Re: Request to Abandon
Groundwater Well S-2-GW
Savage Services Corporation
Savage Coal Terminal
C/007/0022

Title: Removal of Ground Water Monitoring Well S-2-GW

SAVAGE COAL TERMINAL
WATER MONITORING LOCATION MAP

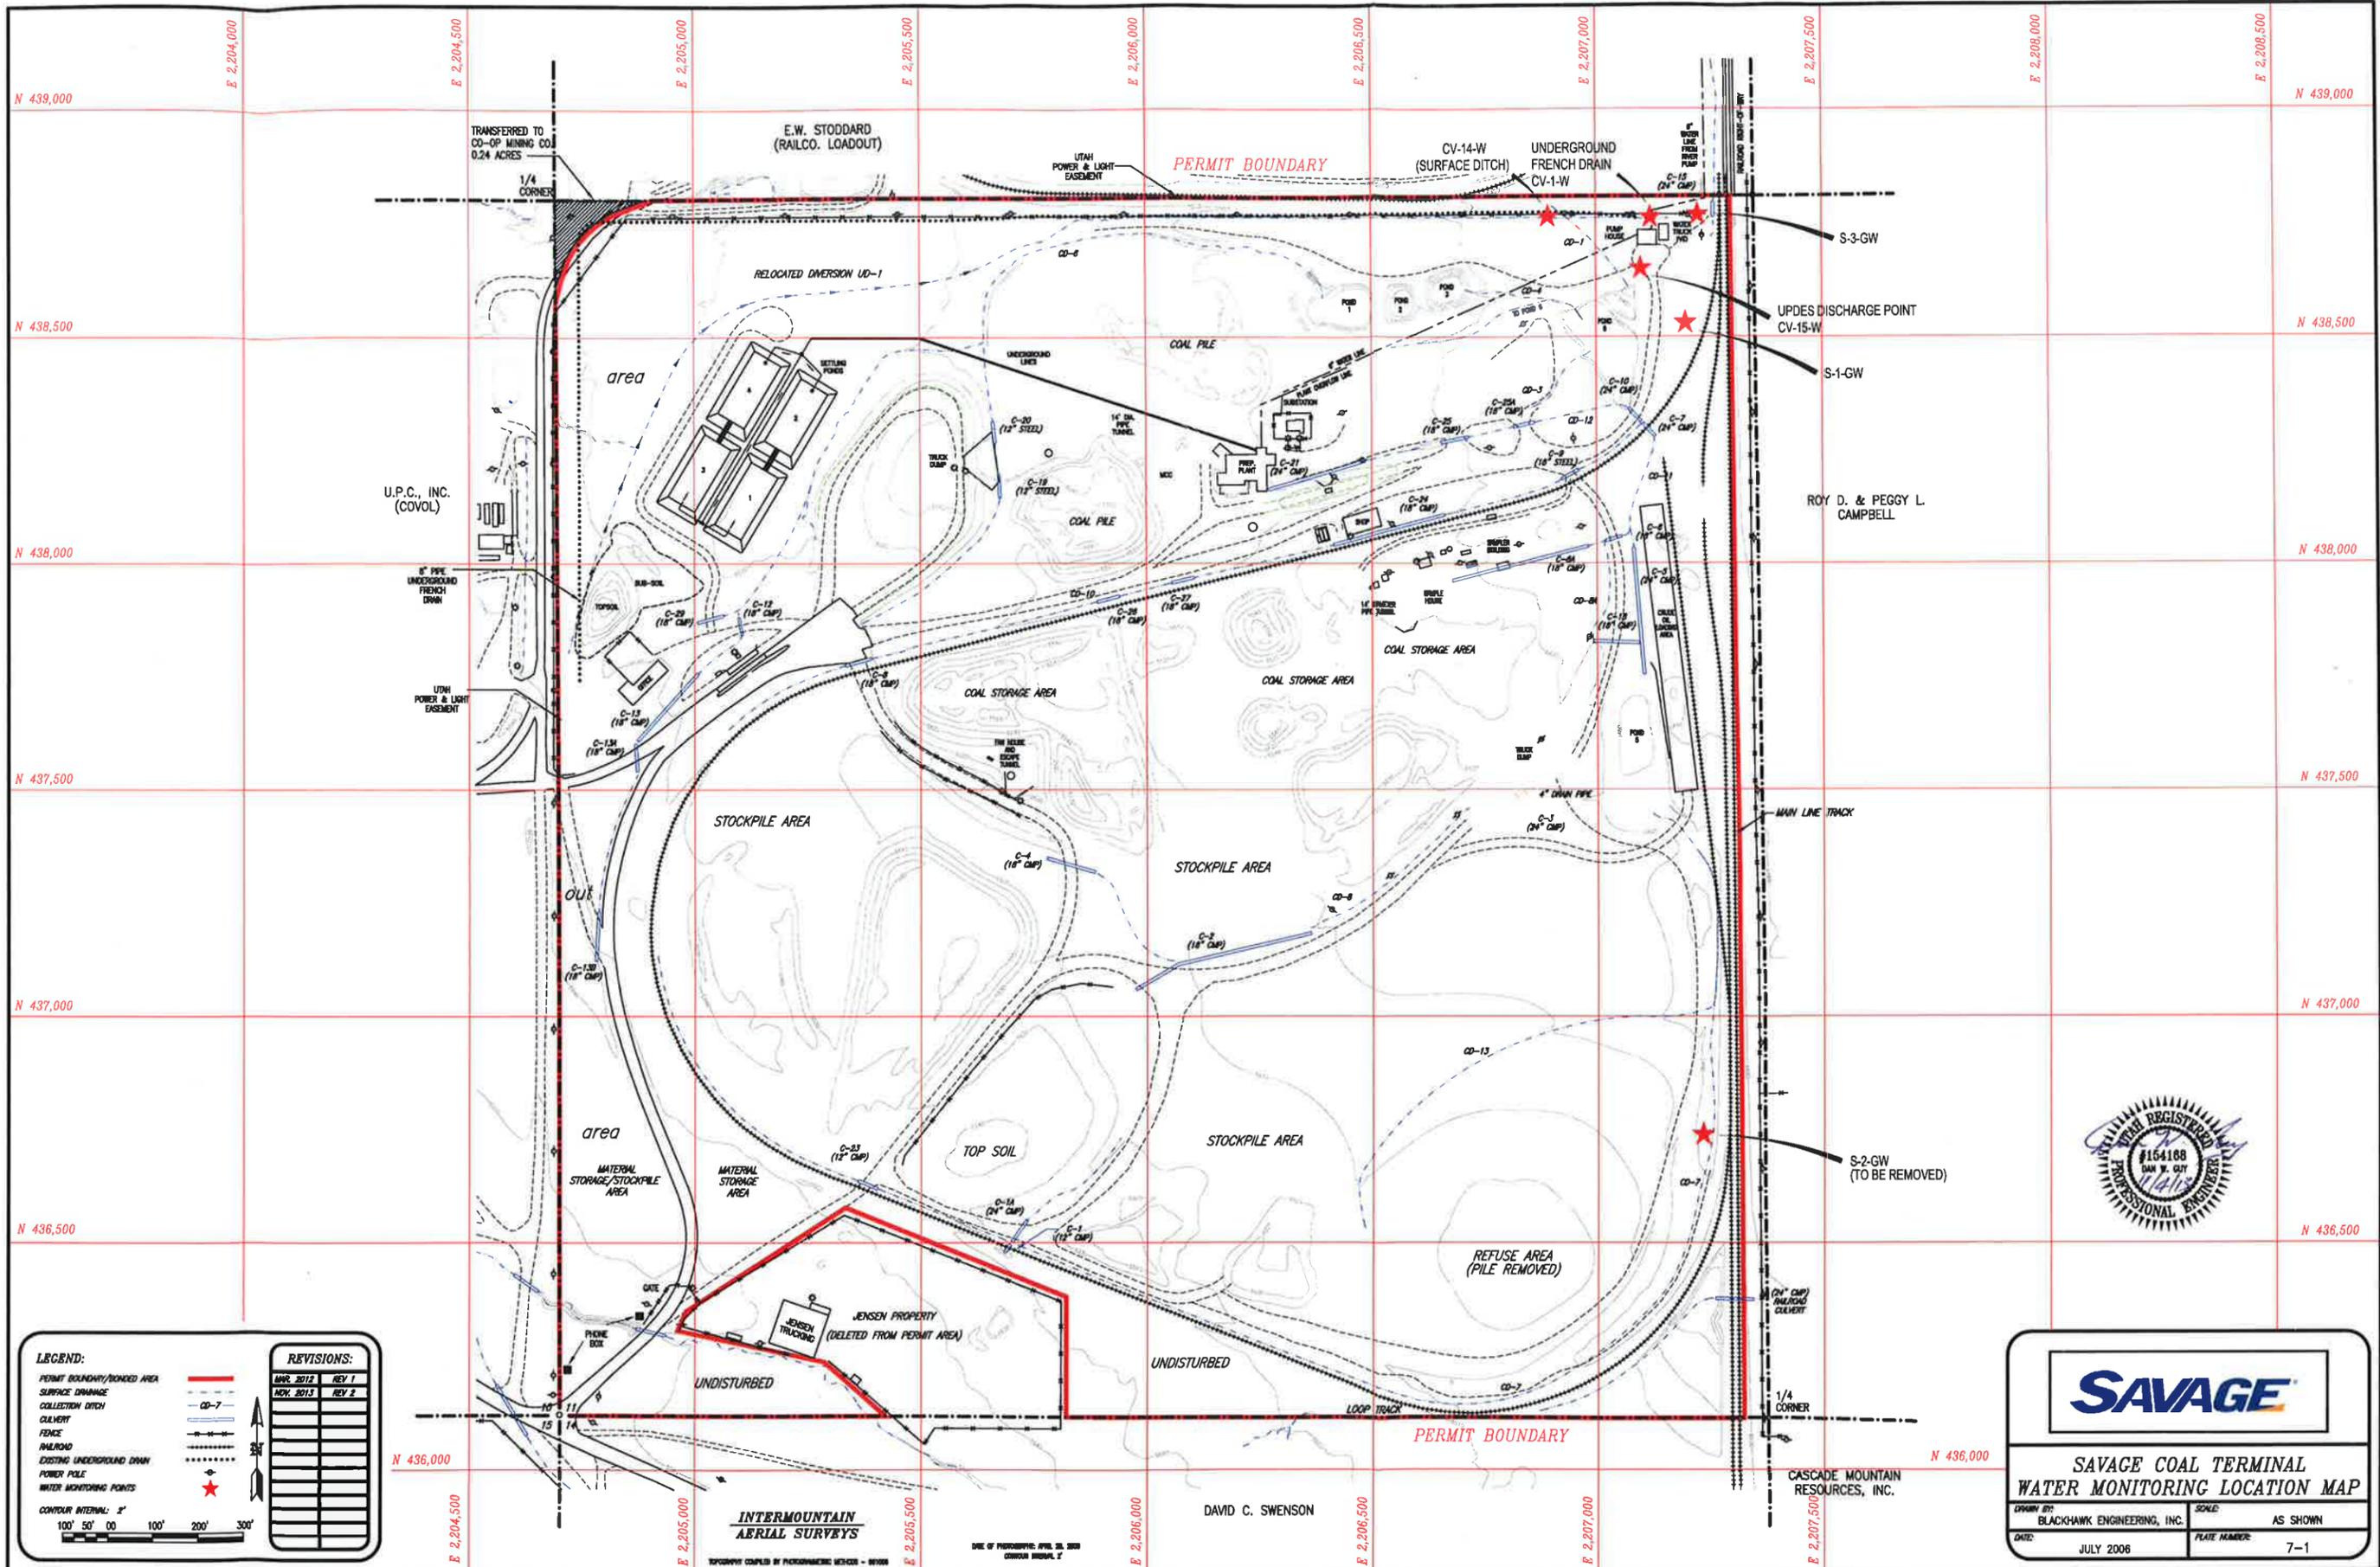
The only proposed change to the present system will be the removal of well S-2-GW, as previously mentioned. Wells S-1-GW and S-3-GW will continue to be monitored according to the approved plan.

S-2-GW
(TO BE REMOVED)

Upon approval, the well pipe at S-2-GW will be cut off at least 6" below ground level and filled with sand to within 12" of the top of the pipe. The upper 12" (minimum) of the pipe will then be filled with concrete and the well abandoned.
